Pipeline Integrity –

Lessons Learned from PHMSA Closed Cases

W. K. "Bill" Deaton, P.E.

Appalachian Underground Corrosion Short Course

Valve V-266 with operator May 2014

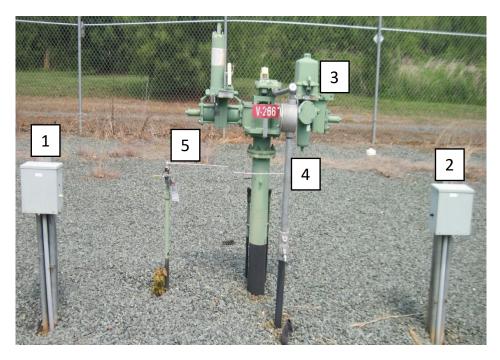
The 2014 records at relative station engineering numbers 76599+25, 76599+26 and 76599+27 (test points 30, 31 and 32), located at the V-266 flow control valve within the Tenaska-Antioch M&R station, indicated the following:

- 1. Inspection remarks: "Mags not interrupted."
- 2. Structure P/S [Pipe to Soil] and Structure IRF [IR Free]:
 - a. Values recorded under the "Structure IRF" column were more negative than the values in the "Structure P/S" column at test points 30 and 31, indicating that current sources may have been interrupted and that IR drop had not been considered.
 - b. Transco Asset Integrity personnel indicated that there are uninterruptable anodes at this location that are not detached during annual CP surveys.

3. The "Native P/S" column of the report was blank. The lack of native pipe-to-soil readings in the "Native P/S" column prevents application of criterion other than the -0.850 Volt Pipe-to-Soil criteria, such as the 100 mV Voltage Shift or 300 mV Criteria found in Transco's 20.06.03 procedure for CP criteria.

Thus, Transco did not demonstrate that IR-drop was considered at these tests points, or that another valid cathodic protection criterion was utilized at this location in accordance with their written

- Upstream insulating flange box with flange wires unbonded. Galvanic anodes connected to the valve side of flange.
- Downstream insulating flange box with flange wires unbonded.
 Galvanic anodes connected to the valve side of flange.
- Gas powered valve operator.
- 4. Control and signal wire conduit connected to operator for control and valve position indication.
- 5. Power Gas connected to operator.

- Interruption could have been performed but it was determined that the operator and associated conduit were not needed anymore. So, it was decided that this equipment would be removed so that the galvanic anodes could be detached, the isolation flanges bonded, and allow the impressed current from nearby rectifiers protect the pipe.
- IR free pipe to soil readings were first required in 2013 but the interruption of small banks of galvanic anodes is difficult to perform due to the resistance of current interrupters. The current interrupters typically do not allow the flow of current due to their internal resistance.
- Despite not taking IR free pipe to soil readings at this location per Procedure 20.06.03, the galvanic anodes have protected the below ground valve and associated piping from corrosion.
